Decision and reasons on Transpower's Bombay Otahuhu Regional major capex project

[2021] NZCC 2

Date of publication: 19 March 2021

Figure D1: Bombay GXP winter peak demand used in the long-list consultation

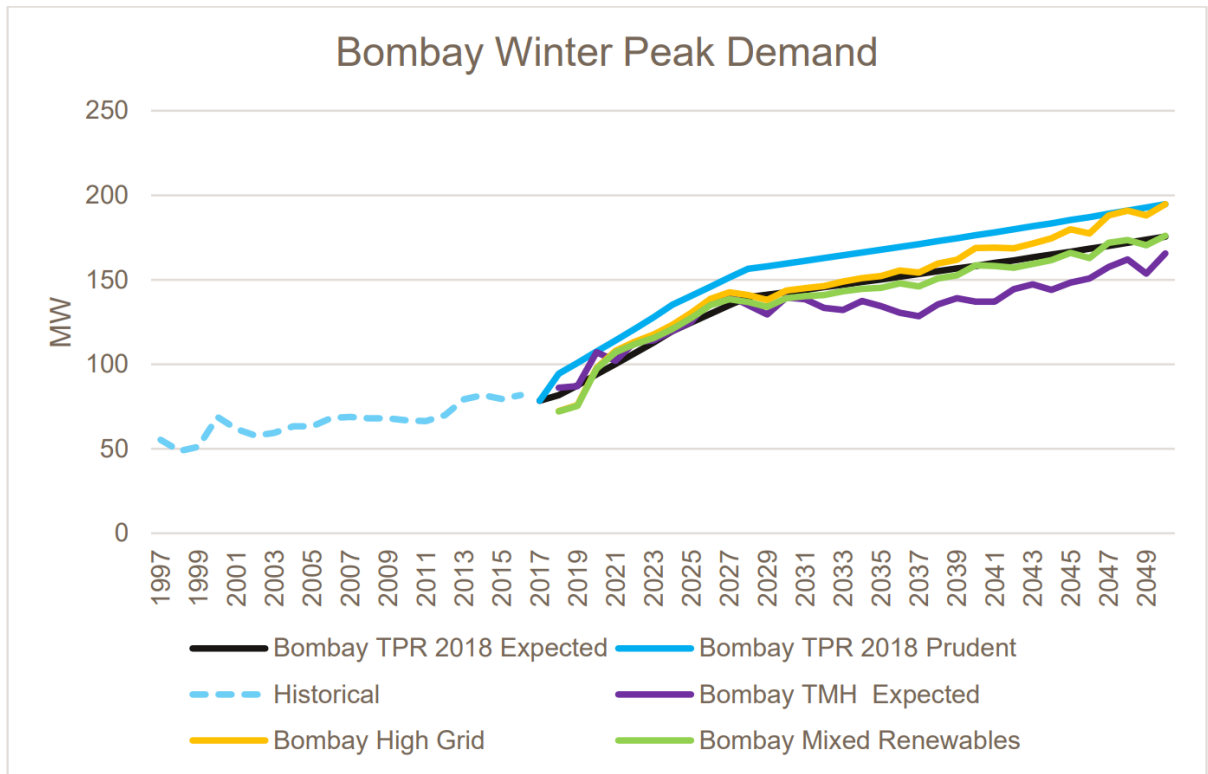
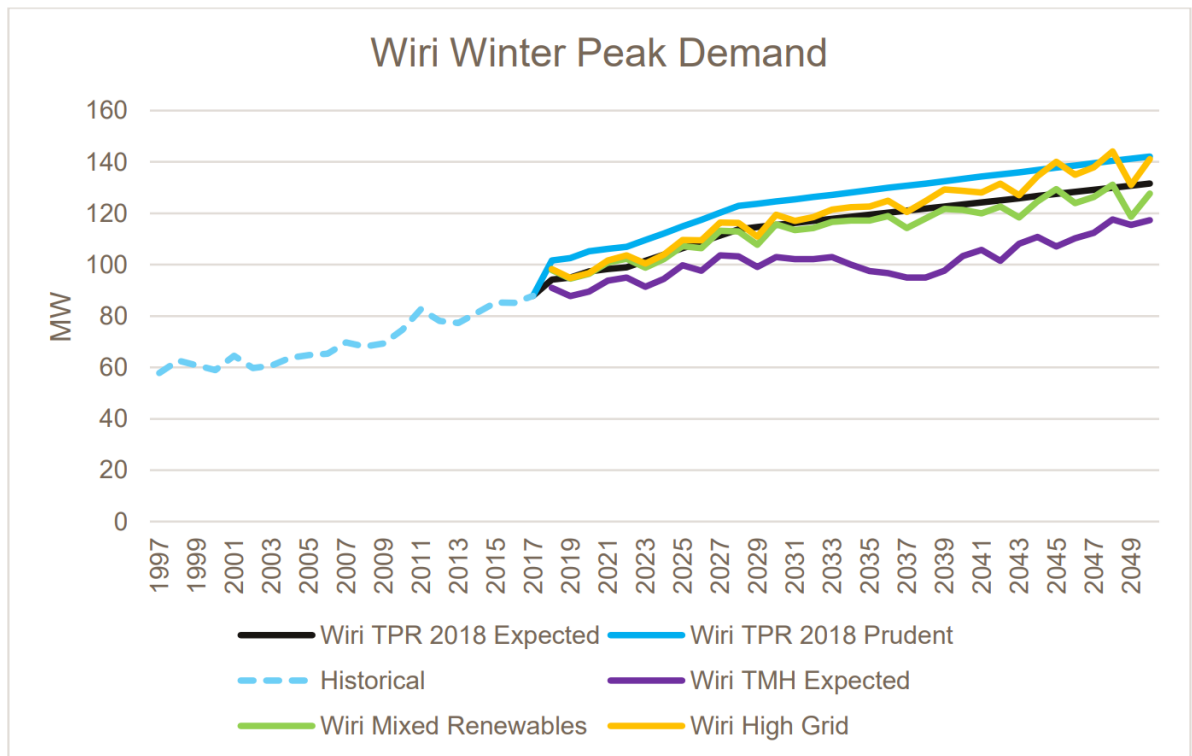
D27 Figure D1 and Figure D2 show the winter peak demand Transpower consulted on as part of its long-list of consultation.²³² Counties supported the forecast stating that the demand forecast for Bombay GXP is in line with its own forecasts.²³³

Figure D3: Distribution of Bombay GXP peak demand forecasts

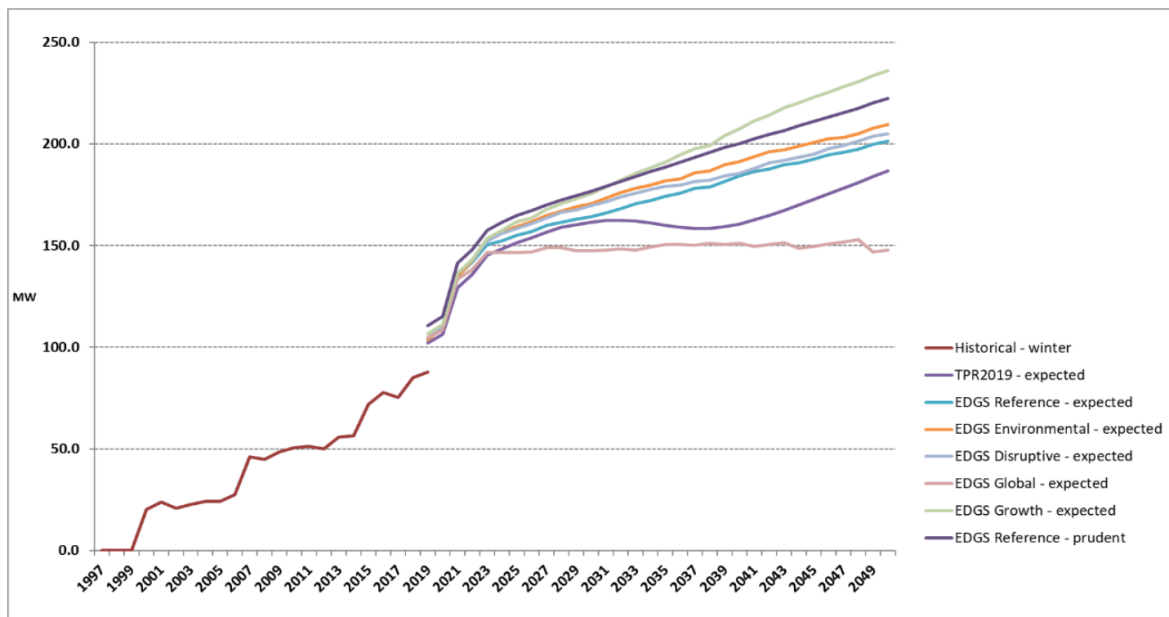
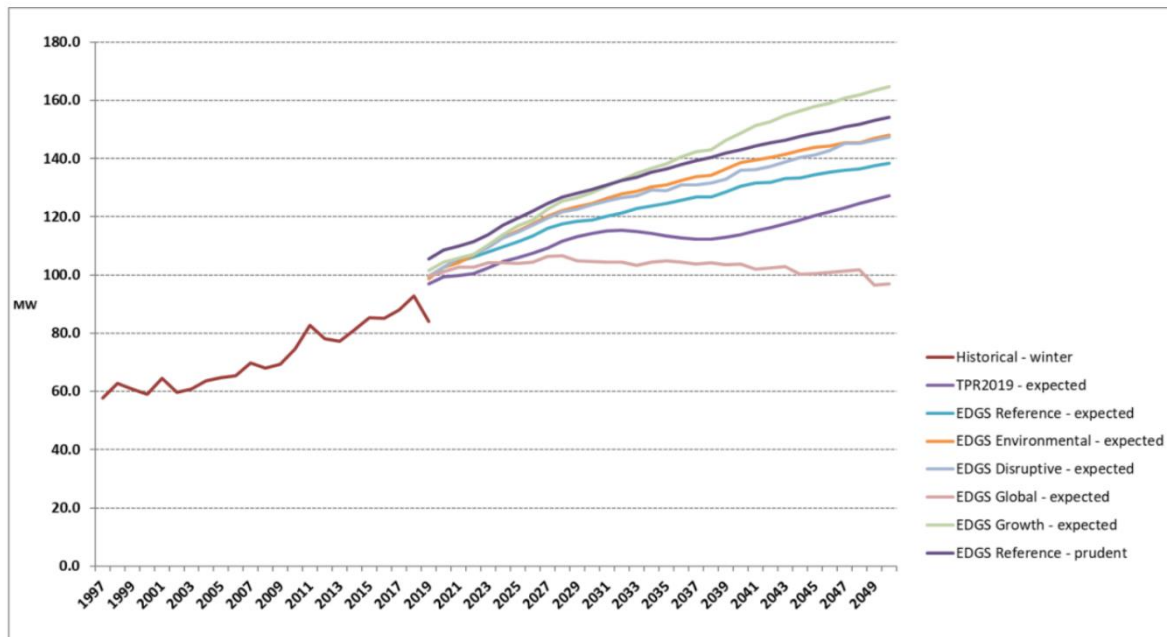
D31.1 the revised demand forecast shows a significant step increase in demand until 2023. We consider that this is unlikely to occur within such a short period, mainly due to the impact of Covid-19;
